ADMINISTRATIVE NOTICE

TO: Distribution
FROM: Carlo Costanza, Executive Director
DATE: October 14, 2020
SUBJECT: Revised Drawings

RE: 251-77 Jericho Turnpike BSA application

Below is a list of changes made from the previous BSA application and their narrative descriptions for the above-referenced project.

DRAWING NUMBER:
BSA-009.1

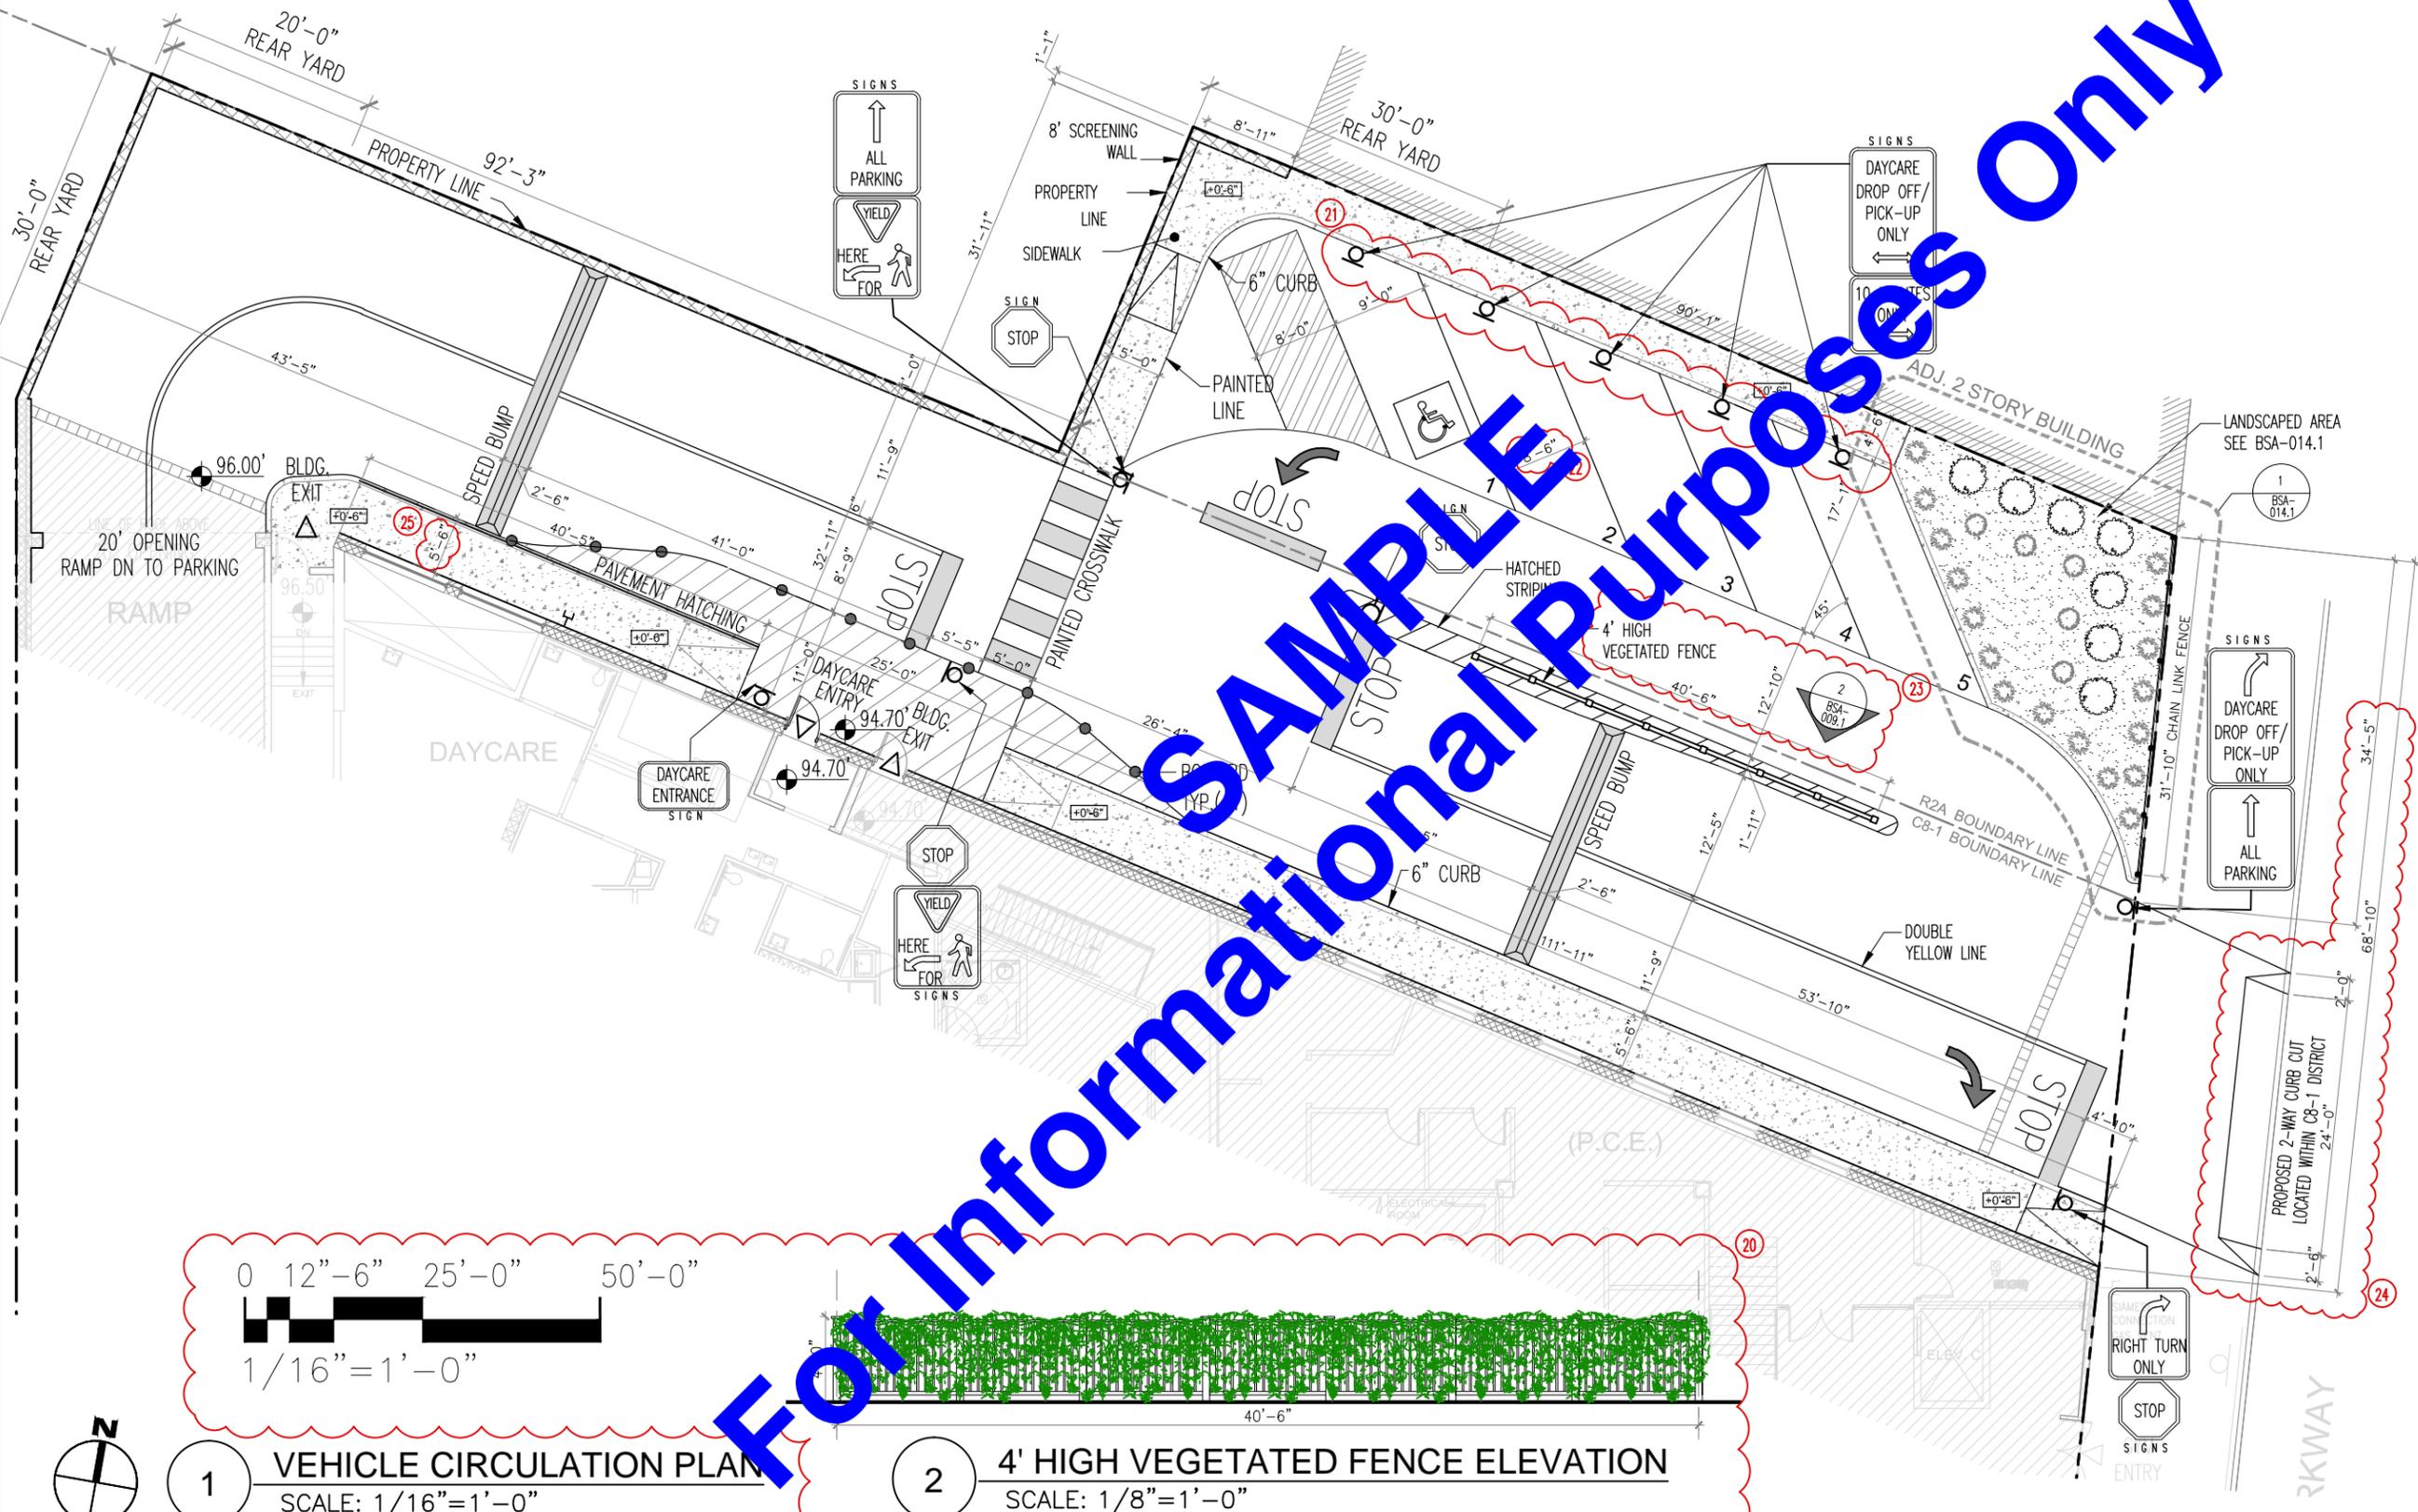
BSA-003.1	17	Note added indicating Vehicle Circulation Plan details on a separate sheet
BSA-005.1	18	Layout of Philanthropic institution updated
BSA-008.1	19	Parking area added
BSA-009.1	20	Scale added and relocated 4' High Vegetated Fence Elevation
BSA-009.1	21	Relocated Daycare drop-off signs to provide more space for the sidewalk
BSA-009.1	22	Parking dimension added
BSA-009.1	23	Note and elevation tag for the vegetated fence added
BSA-009.1	24	Curb cut moved to align with drive aisles and dimensions updated
BSA-009.1	25	Dimension clarified.
BSA-014.1	26	4' High Vegetated Fence Elevation relocated to Sheet BSA-009.1
BSA-002.1	27	Vehicle circulation path added
BSA-003.1	28	Mailbox added
BSA-003.1	29	Video intercom (monitor) at 1 st floor reception added
